GROUP	MODEL
BOD	2023MY Telluride (ON)
NUMBER	DATE
320	June 2023

SUBJECT: **FRONT DRIVER DOOR BELT OUTSIDE  
WEATHERSTRIP INSPECTION/REPLACEMENT (SA535)**

This issue number is SA535.

### Inspection Procedure:

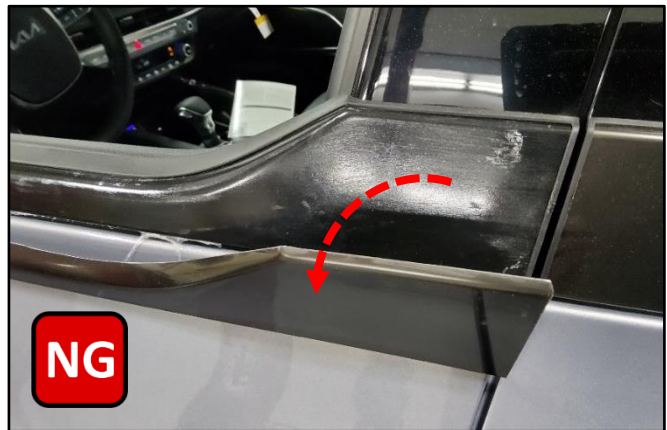
1. Confirm that the outer faceplate is not detached/separated (coming unglued) from the molding by gently pulling using fingers:

- If the outer faceplate is not detached or separating from the molding (OK), no further action required.

- If the outer faceplate is detached or separating from the molding (NG), proceed to the 'Replacement Procedure' below.

### Replacement Procedure:

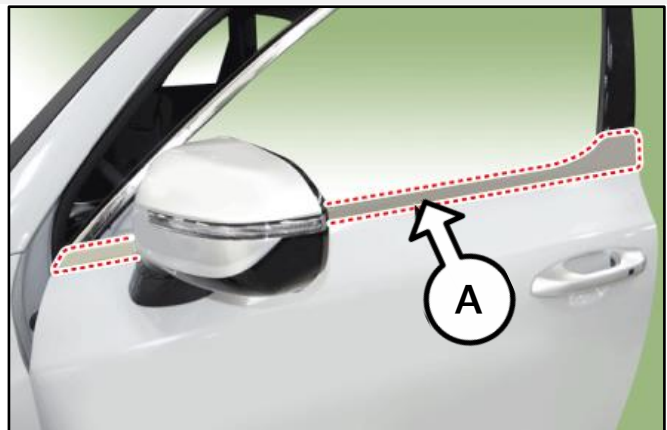
1. Remove the front door weatherstrip (A) by referring to "Body (Interior and Exterior) → Front Door → Front Door Weatherstrip → Repair procedures" in the applicable Shop Manual on KGIS.
